FAIRBANKS-MORSE

BULLETIN FM194

NEW END CAP FOR TYPE FM-XV4C73 VERTICAL MAGNETO

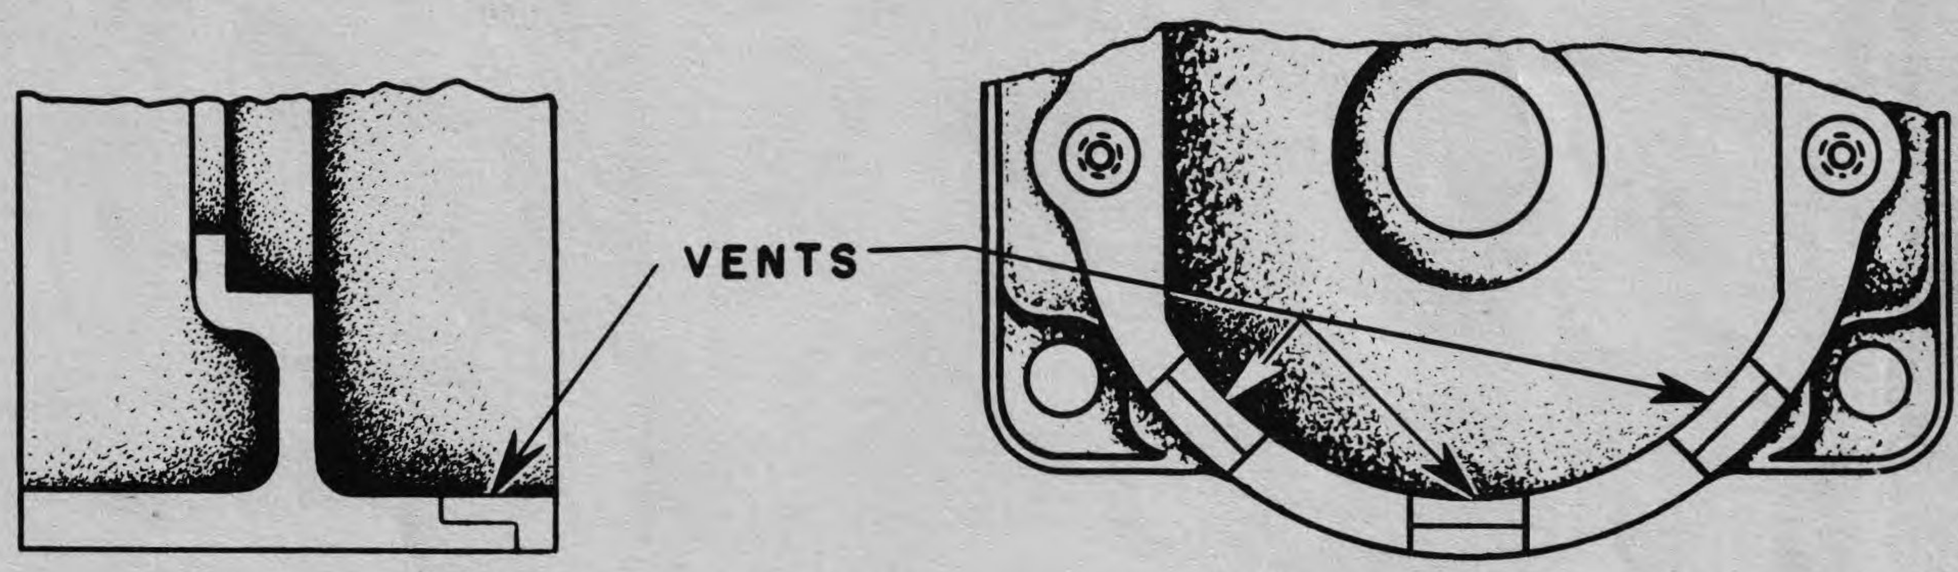
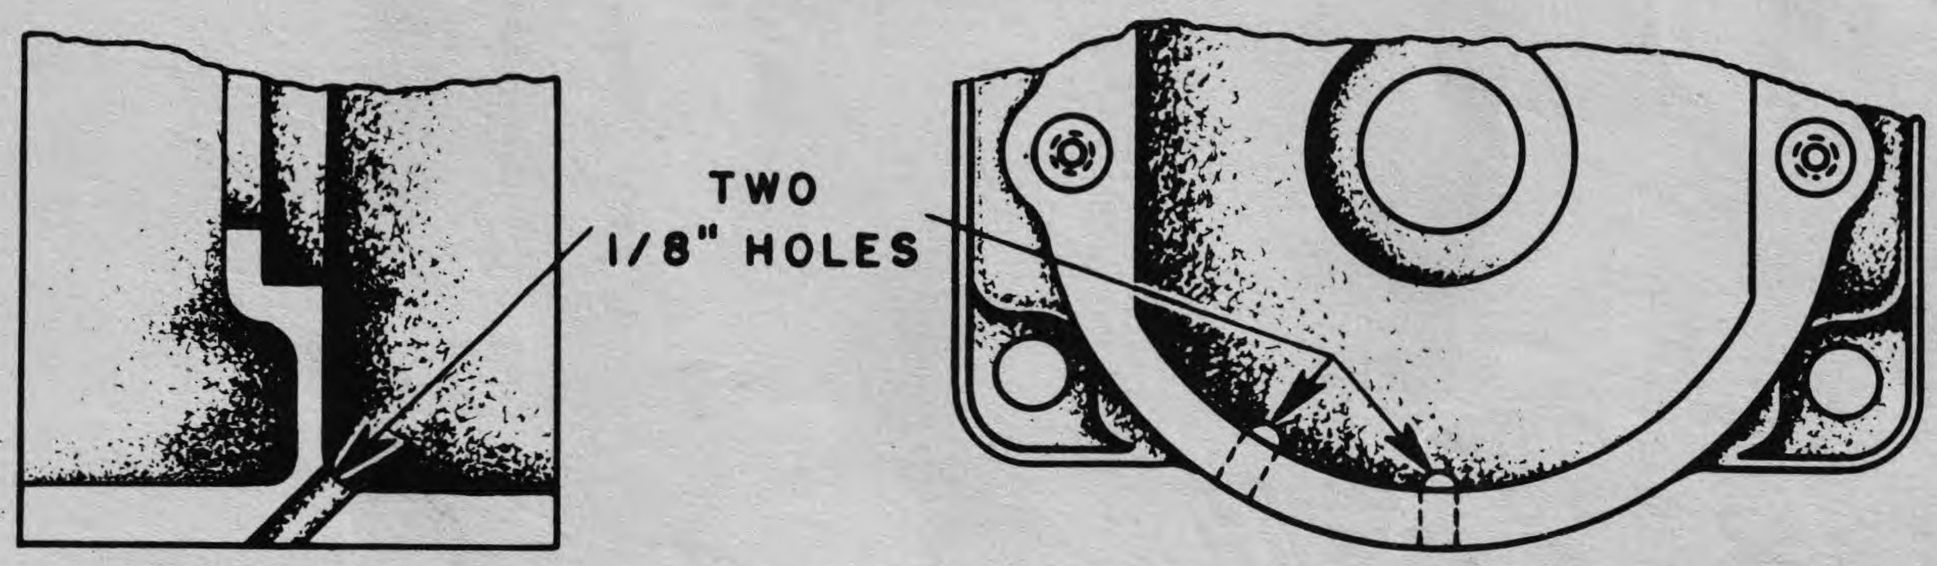
Reports from the field indicate that during rain difficulty has been experienced with the FM-XV4C73 vertical magneto due to water getting into the end cap through the present vent holes.

End cap GX2430 originally used on this magneto should be replaced, no charge, by end cap identified as LY2430 on all FM-XV4C73 magnetos. If the magneto has not been used, the GX2430 end cap removed may be returned for credit.

If a magneto is brought in for repair which has seen service and water has collected therein, the magneto should be disassembled, the water removed, both the distributor chamber and the inside of magneto cleaned and dried thoroughly, and restored to a serviceable condition, using the LY2430 end cap, all at no charge. There is also the possibility that in some cases the magnetic rotor should be replaced, also on a warranty basis.
